FliteCharts Data Alert 26137

DATE: September 3, 2026

AIRPORT: Teterboro Airport, Teterboro, NJ (KTEB)

SUBJECT: Obsolete RNAV G RWY 01 (GUIDED VISUAL) chart

KTEB RNAV G RWY 1

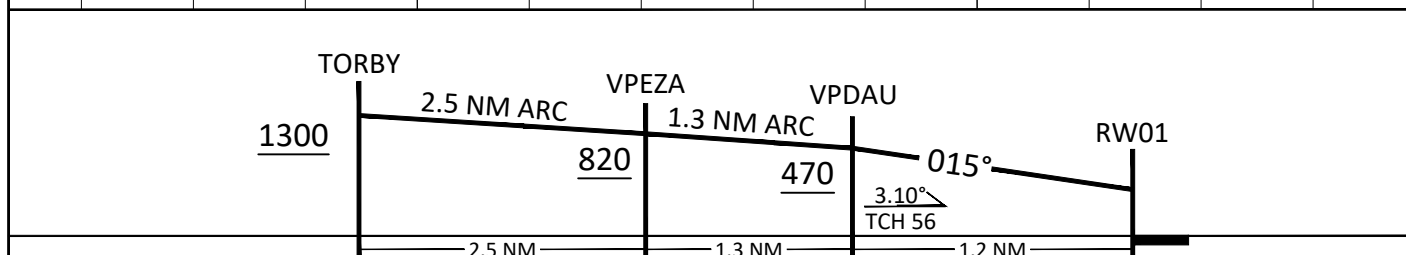
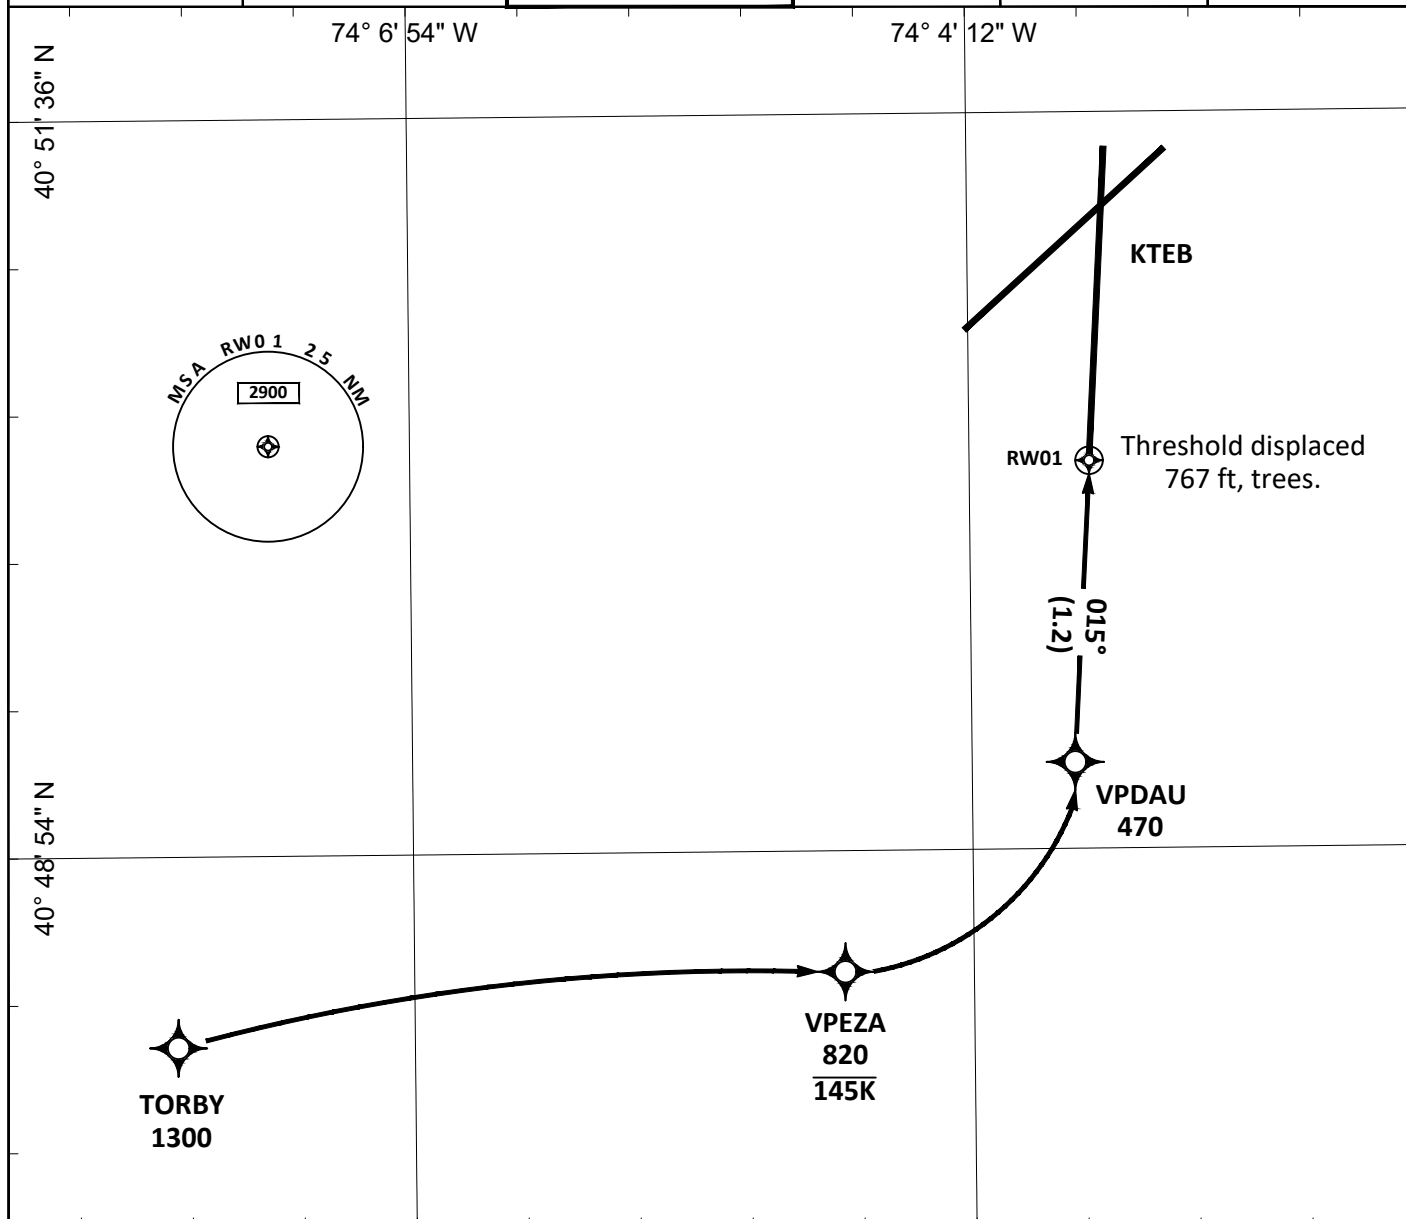
An obsolete RNAV G RWY 01 (GUIDED VISUAL) chart at Teterboro Airport, Teterboro, NJ (KTEB) was included.

Refer to the attached RNAV G RWY 01 (GUIDED VISUAL) chart on pages 2 and 3 of this alert.

The affected chart will be included in cycle 2610 of the US with Guided Visuals and North America with Guided Visuals FliteCharts databases for applicable Garmin aviation products and in Garmin Pilot. Cycle 2610 FliteCharts databases are effective October 01, 2026 and will be available September 29, 2026.
